THE CITY OF WALTHAM
MASSACHUSETTS
PURCHASING DEPARTMENT

Trapelo Road Water Services, 2018

ADDENDUM NO. 1

November 30th, 2018

GATE VALVE AND BOX

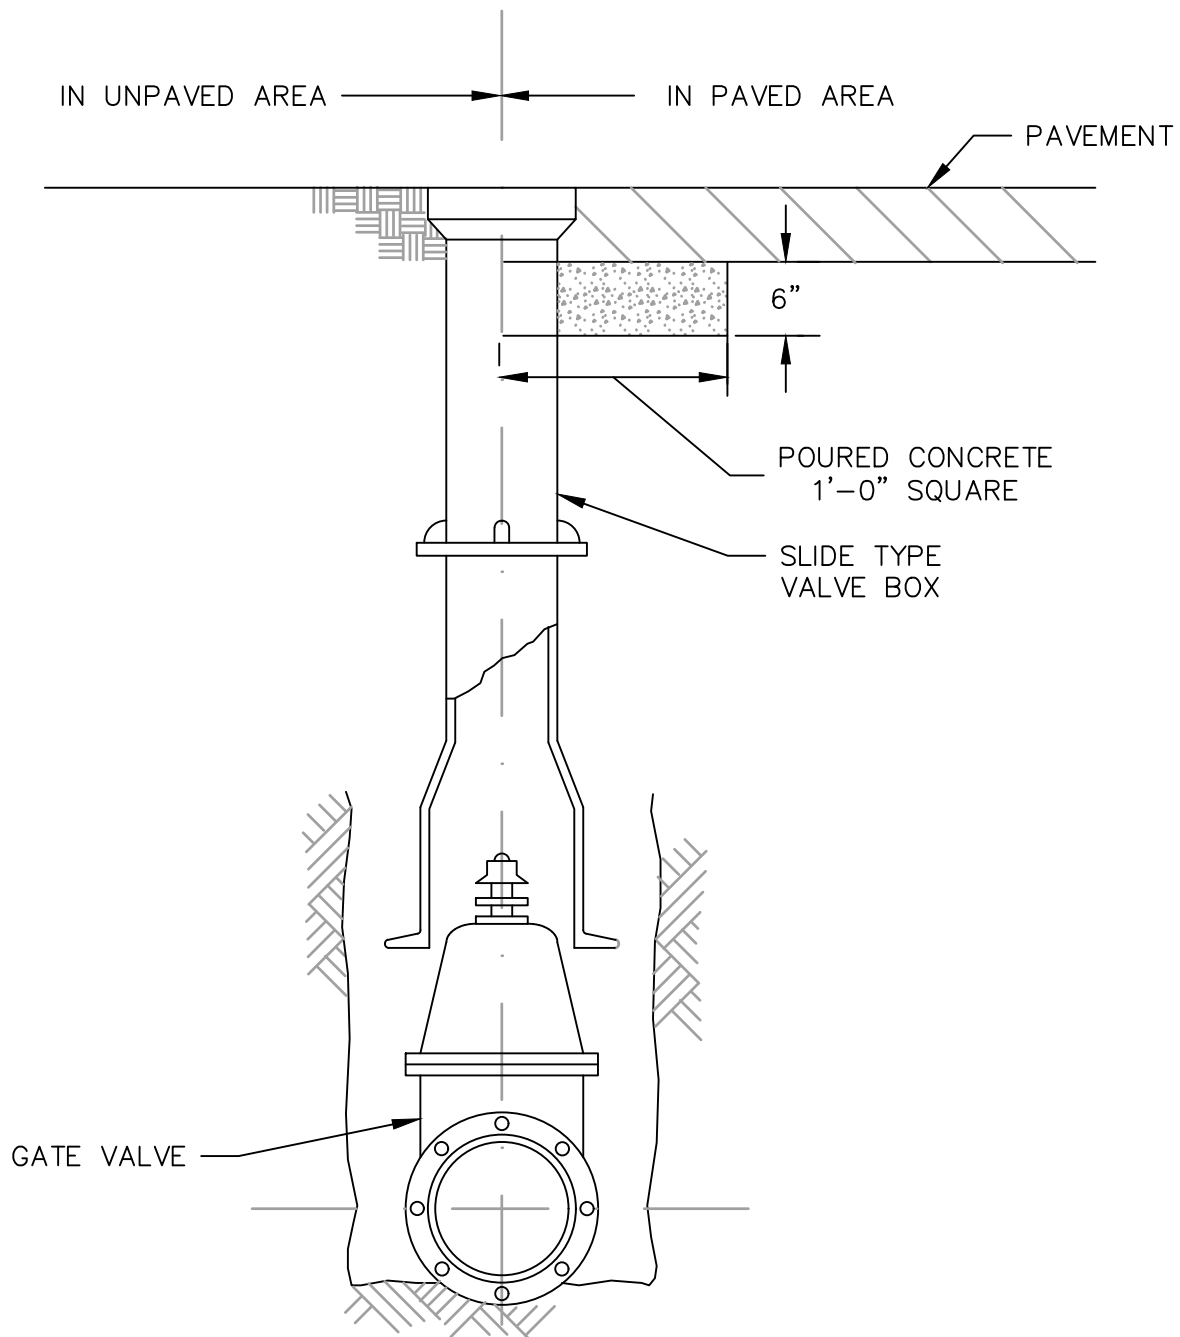
c. Hydrant replacement
A4-c. *See Attached detail W-5 Typical Fire Hydrant*
d. Gate valve replacement
A4-d. *See Attached detail W-1 Gate Valve and Box*
- Q5.** What is the thickness of the existing asphalt on Trapelo Road.
A5. *Unknown but assumed to be greater than 5"*

TYPICAL WATER SERVICE

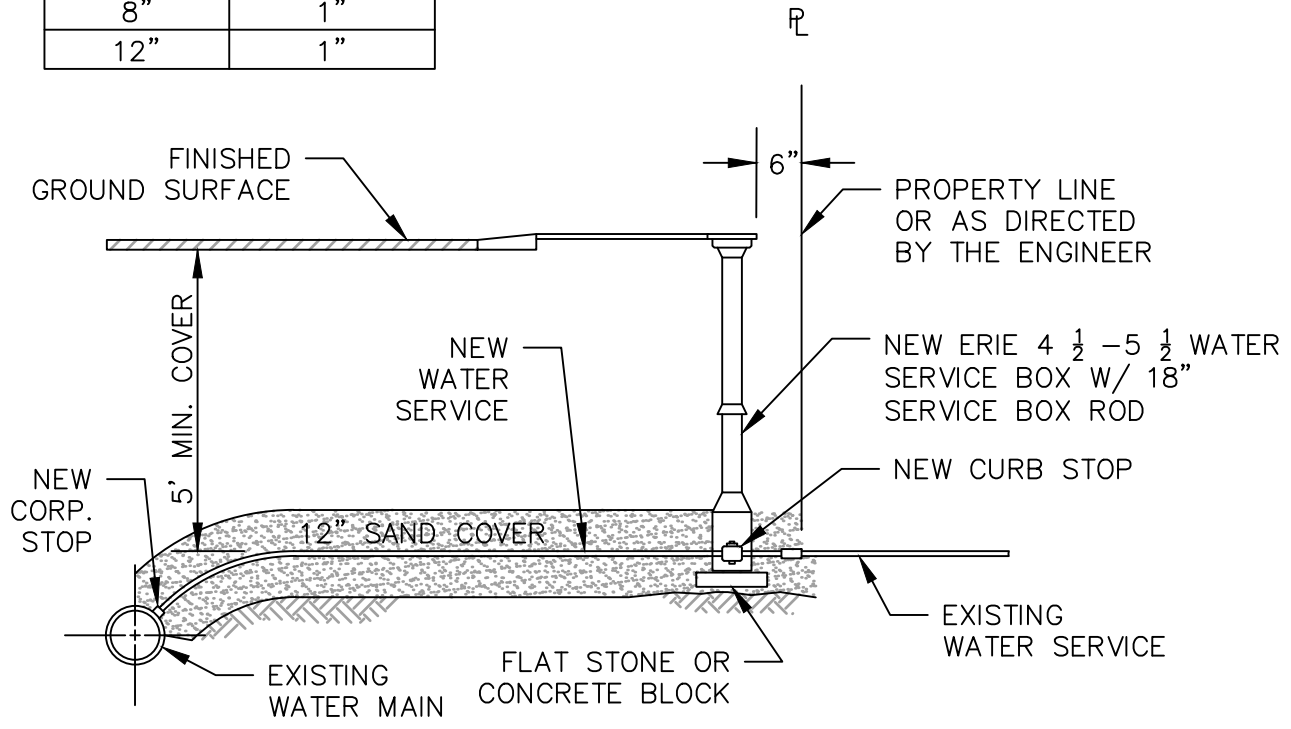
a. Water Service replacement
A4-a. *See Attached detail W-7 Typical Water Service*
b. Sewer Service replacement
A4-b. *See Attached detail S-3 Sewer Service Detail*
